Status: Y N U**Seismic Walkdown Checklist (SWC)**Equipment ID No. 1-1805-53-015 Equip. Class¹² ZEquipment Description 480V Switchgear 1AD15Location: Bldg. Aux/41 Floor El. 119'-3" Room, Area RD105

Seismic Walkdown Checklist (SWC)

Equipment Description 480V Switchgear 1B07

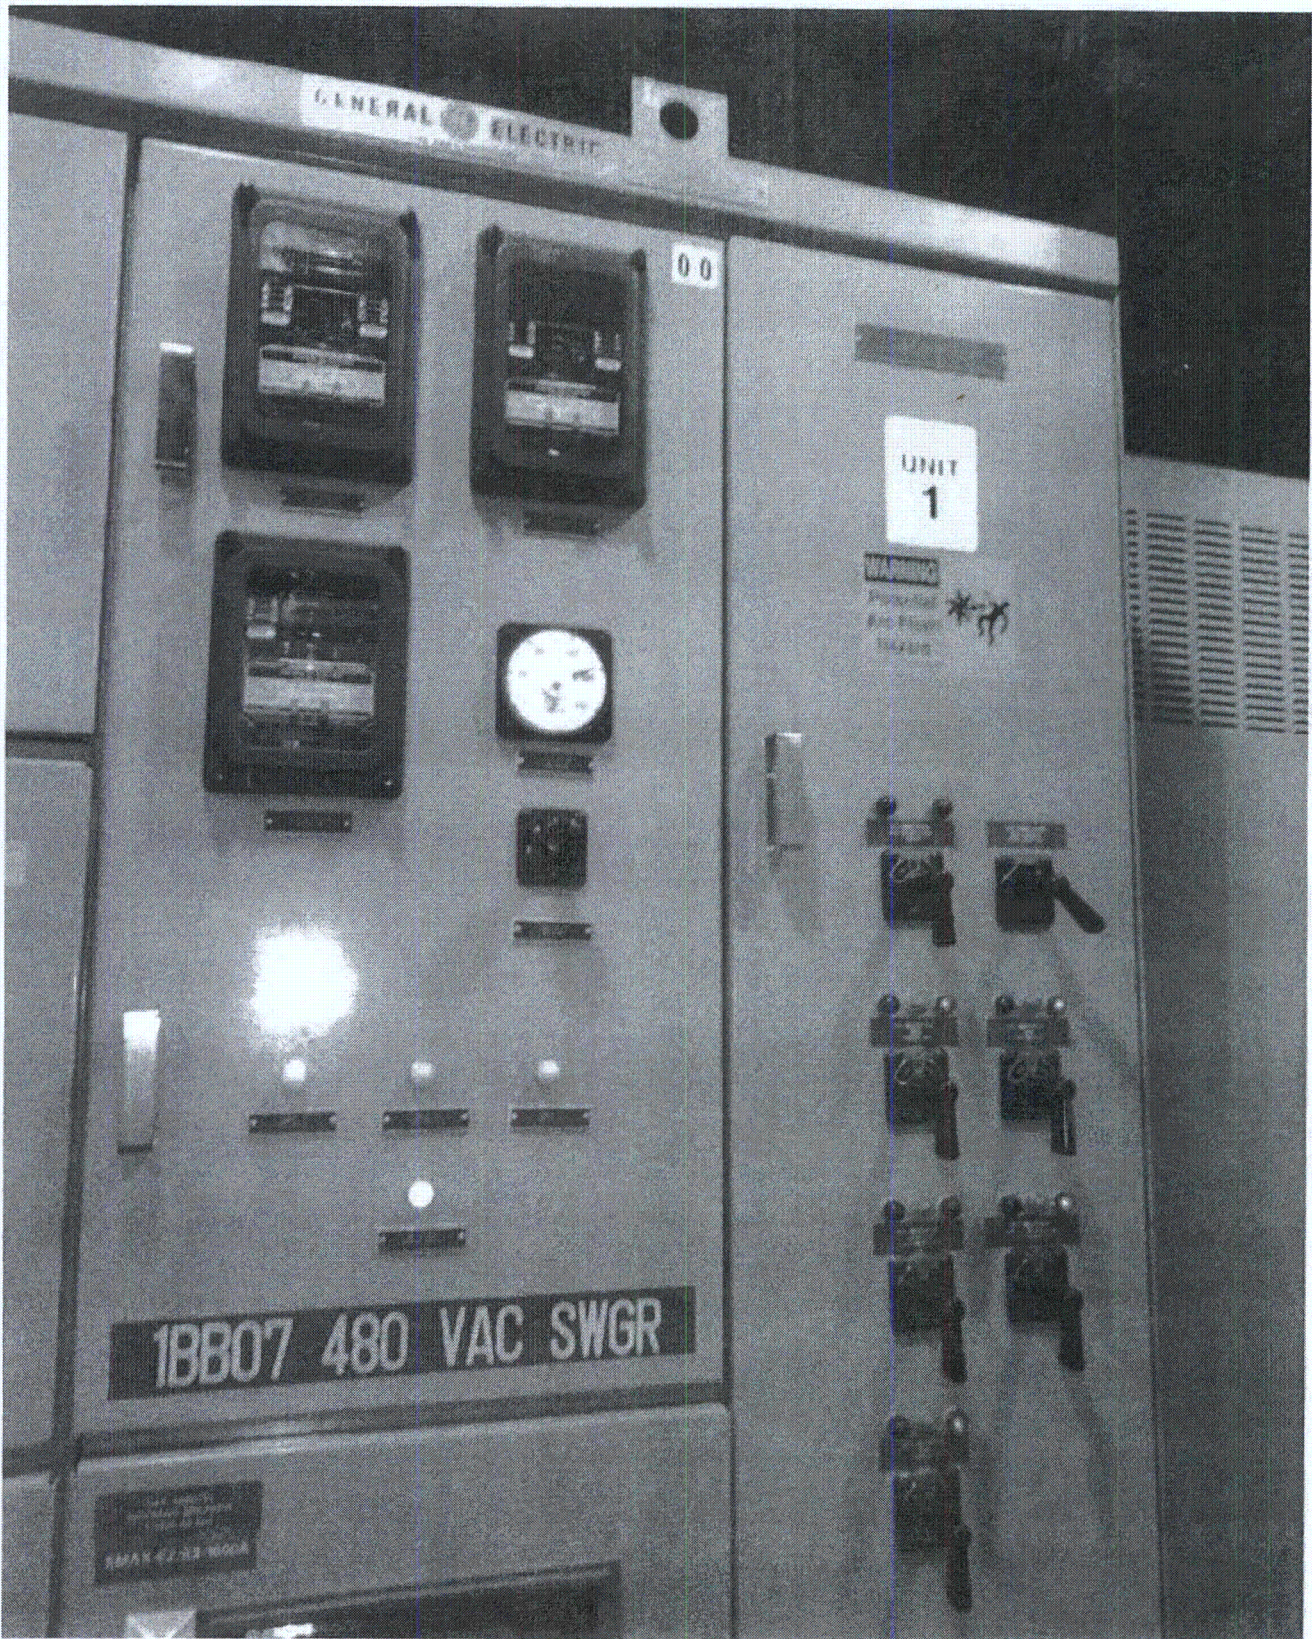
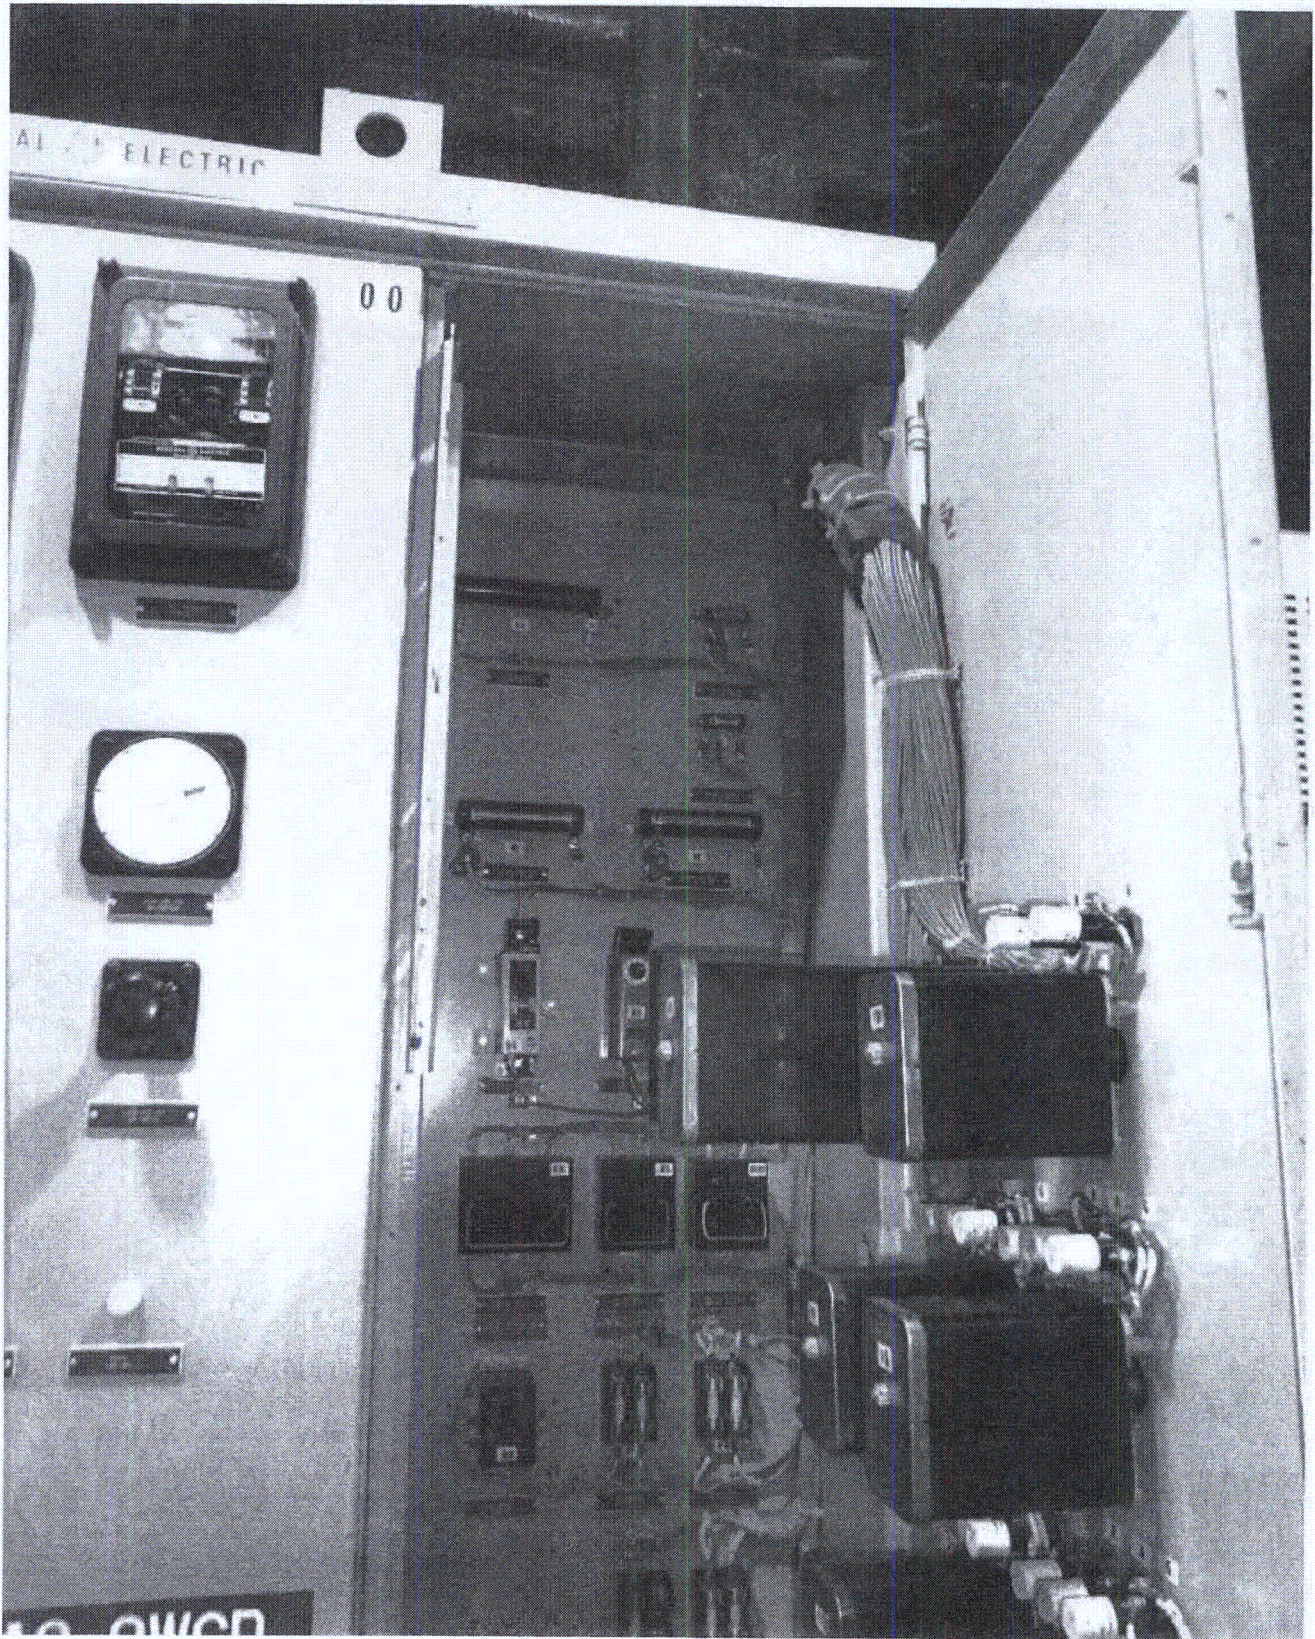
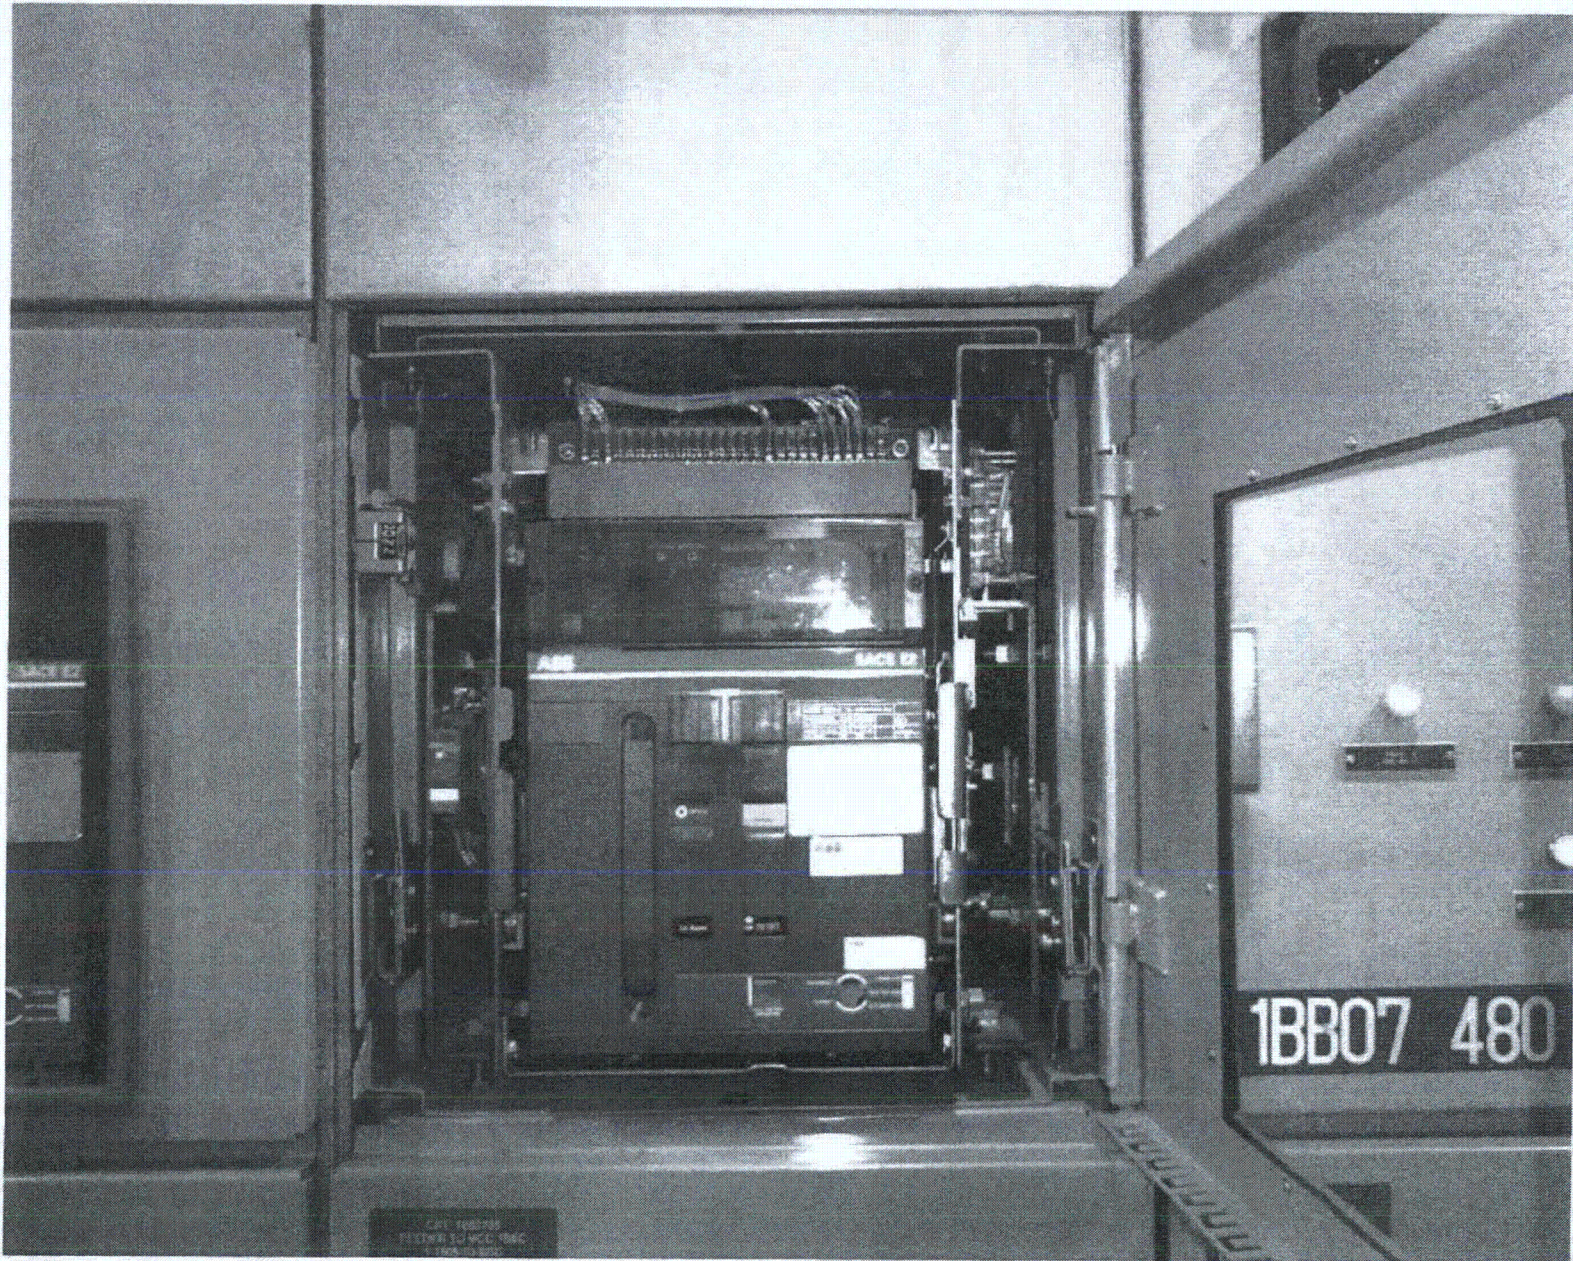
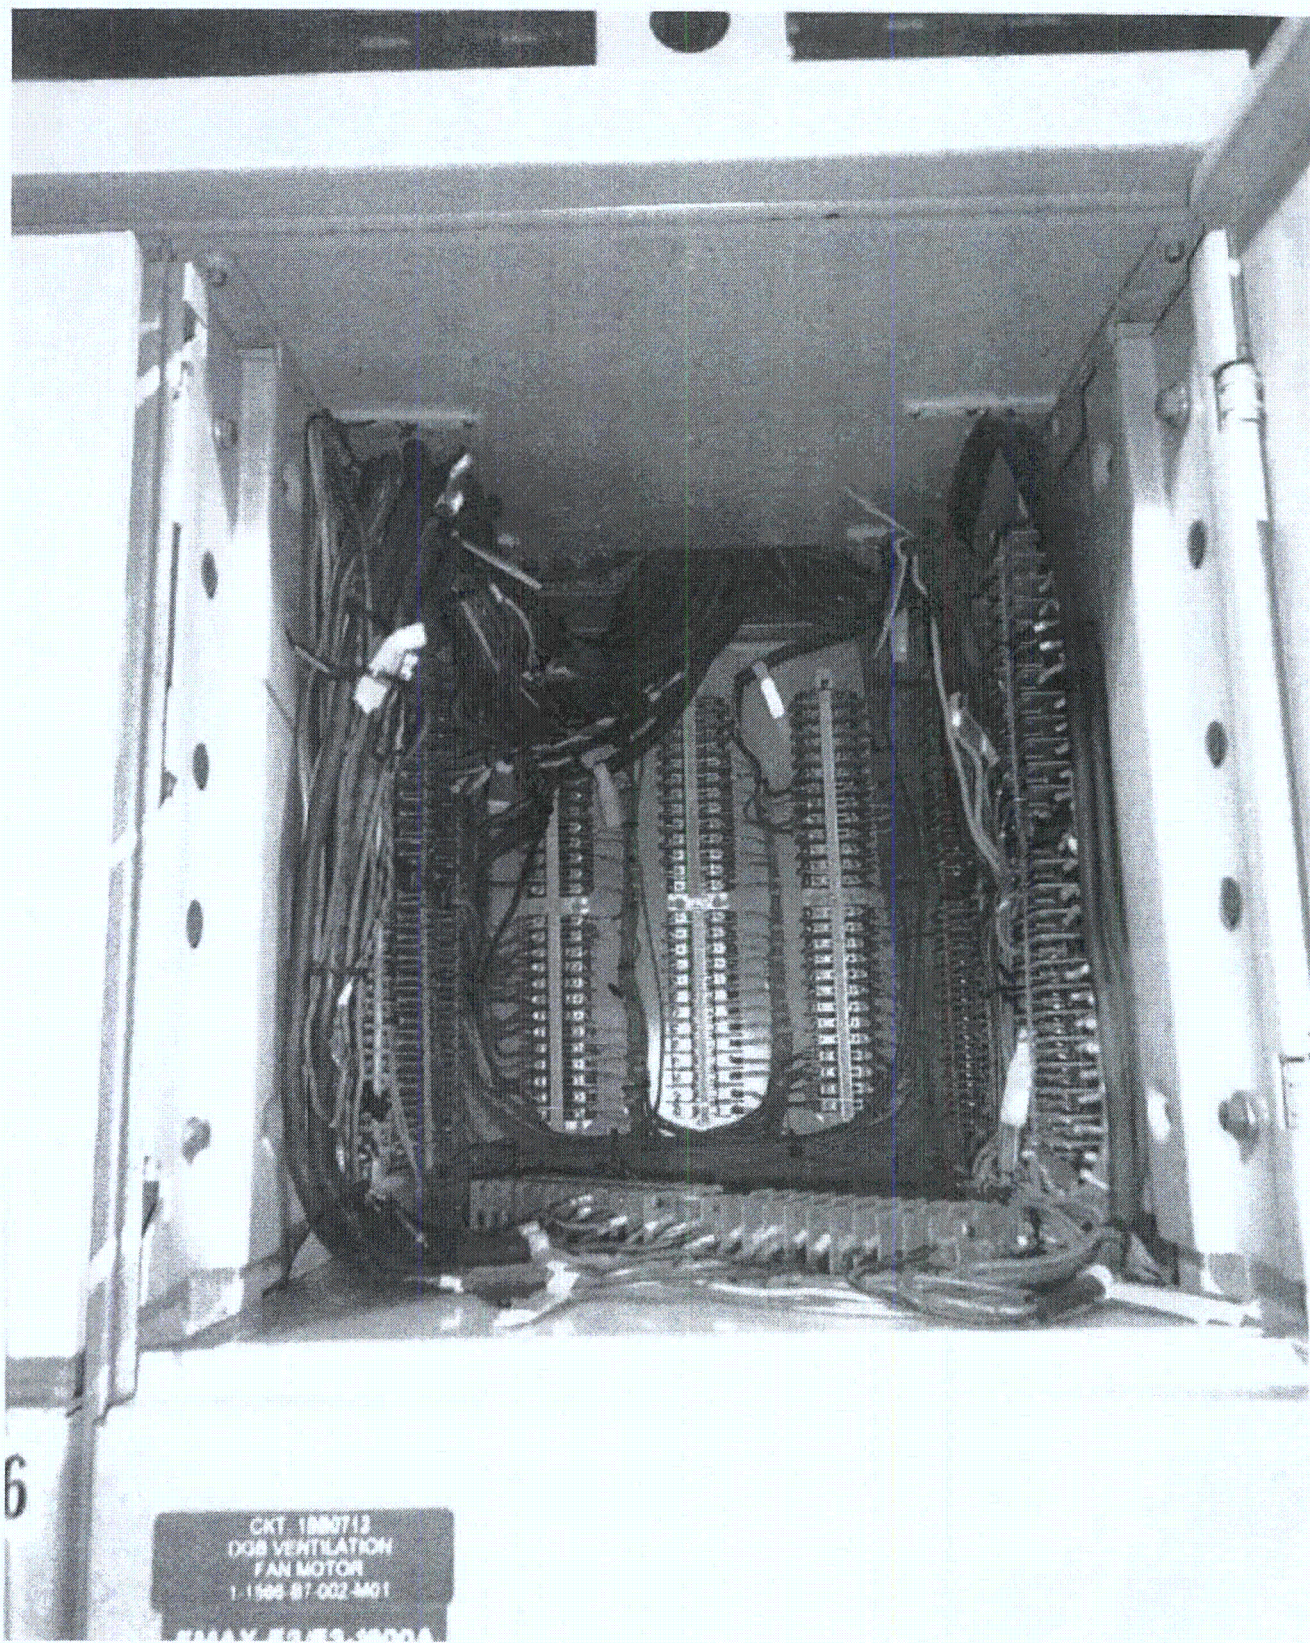
- ① Found 1 inter connecting fastener missing which connects cabinet's bays 1B0710 and 1B0714. Condition Report 527135 has been generated to evaluate seismic adequacy.
- ② Found 1 tie wrap broken used to support a cable bundle in bay 11. This is not a seismic or vulnerability concern. Ref. CR 528379
- ③ Found 2 (two) door hinge pins partially with drawn on bay 18. This is not a seismic or vulnerability concern. CR 528379
